A ground-floor shower · design review G-07, ageing in place · three positions compared · Taif / Palm House V8.1 · STUDY ONLY

DEFERRED to the plumbing study by the owner (2 Nov 2026): P1 preferred, P1-lite the fallback. 2 Nov 2026 · today the ground floor has the family WC, the guest WC and the maid bath (the only shower, the maid's) · a level walk-in shower ≥ 0.9 × 1.2 m, a 1.5 m turning circle where possible, access from the family side, a drain to a stack, ventilation, privacy · nothing in the design files changes until the owner decides · all sizes assumed

P1 · the family WC and the family basins become one accessible wet room (recommended)

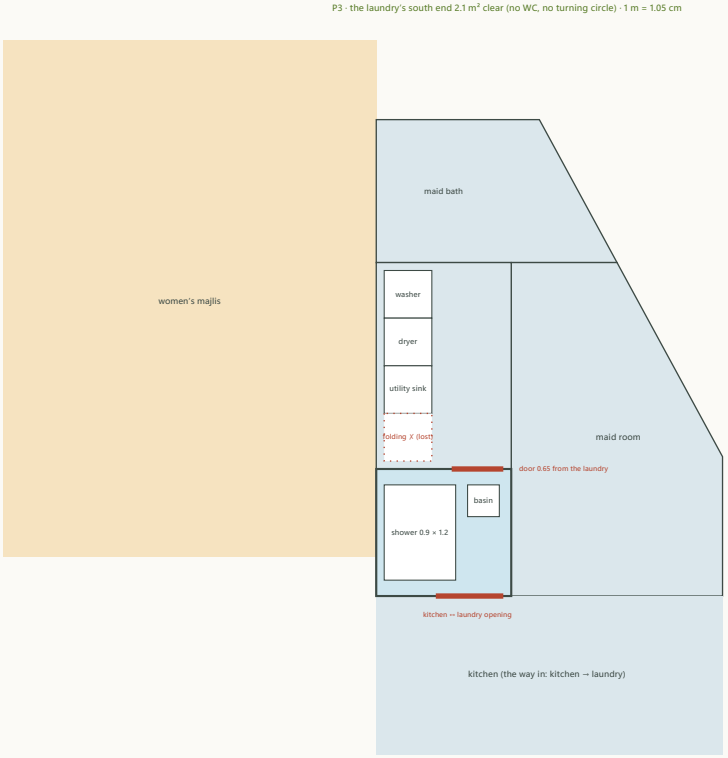
- **Where:** the west wash block, x 0–2.75, y 12.9–16.1: the two rooms merged by removing the wall on y 14.4; **2.53 × 3 = 7.57 m² clear**.
- **Layout:** the **wudu basin counter kept** on the north wall (two basins, 1.2 m); a **level walk-in shower 1.2 × 1.2** at the south-west corner (a fold-down seat, grab rails, a curtain or a half screen, the floor falling to its outlet: the ground slab is on grade, so the floor is lowered locally with no beam in the way); the **WC** at the south-east corner with grab rails both sides; a **1.5 m turning circle** in the middle (the level shower zone may be part of it); a **1.0 m sliding door** on the riwaq side (no swing in the 1.30 m riwaq), parking on the 1.9 m of wall south of it. Non-slip tiles, a hand shower, lever taps, a night light.

- **Access:** from the riwaq (the family side), 3 m from the lift, never through the guest side. **Drain:** the shower outlet into the west drain run under the wash block beside the existing WC stack (one run, as decided). **Ventilation:** a small west window (sill +1.8, under the first-floor bath 3's window) plus an extract fan. **Privacy:** its own door; the shower and the WC at the south end, out of the door's sight line; the basins by the door.

- **Effect on the rooms around:** the **open wudu basins** (open to the riwaq today) are now **behind a sliding door that stays open by day**: the one real loss; the hospitality kitchen, the serving passage, the utility room and the riwaq are untouched. **Structure:** the GF wall on y 14.4 carries the hidden beam **B14** under the first-floor wall between bedroom 2 and bath 3: without the wall, B14 becomes a **drop beam 0.25 × 0.45** spanning 2.75 m from the west wall to B10, hidden in the wet room's gypsum ceiling (the house rule): the engineer.
